**NARRAGANSETT BAY COMMISSION
ONE SERVICE ROAD PROVIDENCE, RI 02905**

**CSO PHASE IIIA
OF-217 Consolidation Conduit
CONTRACT 308.05C**

**ADDENDUM NO. 1
August 19, 2021**

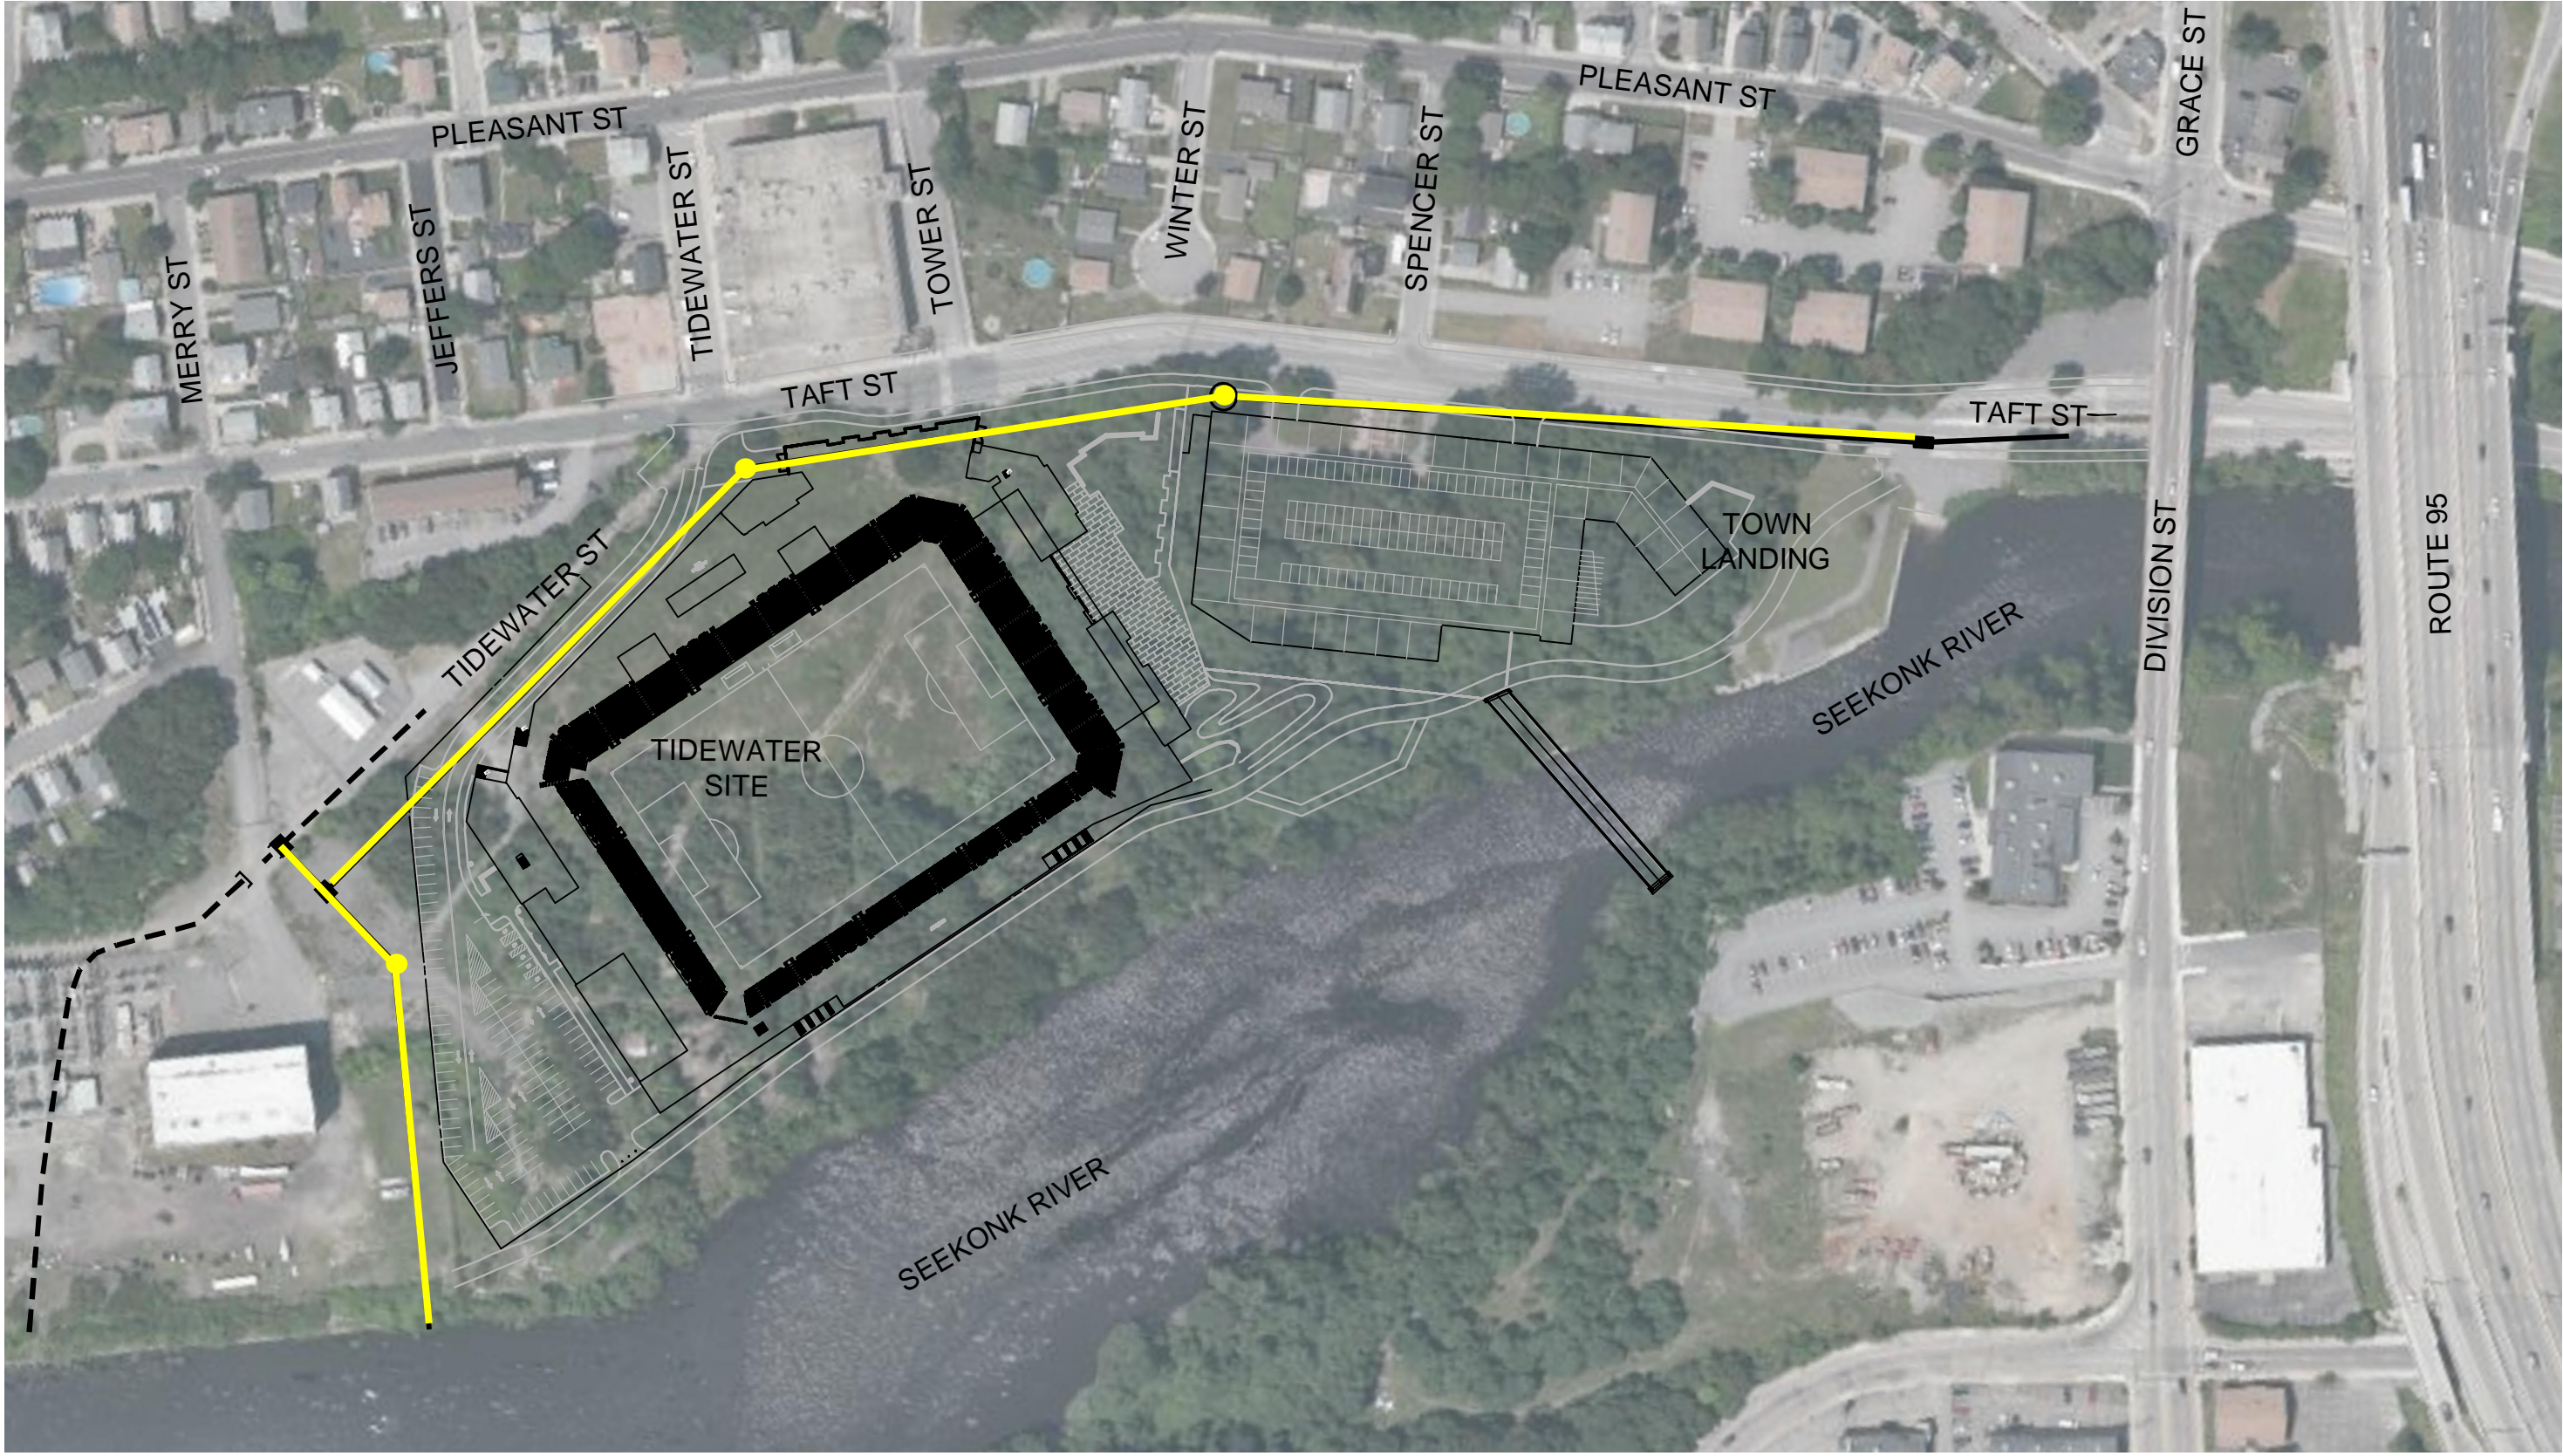
3. Please provide records for test pits 320 and 321?

Response: Test pit 320 is included within Appendix E of Contract Specifications and here for convenience. Test pit 320A and 321 are also provided.
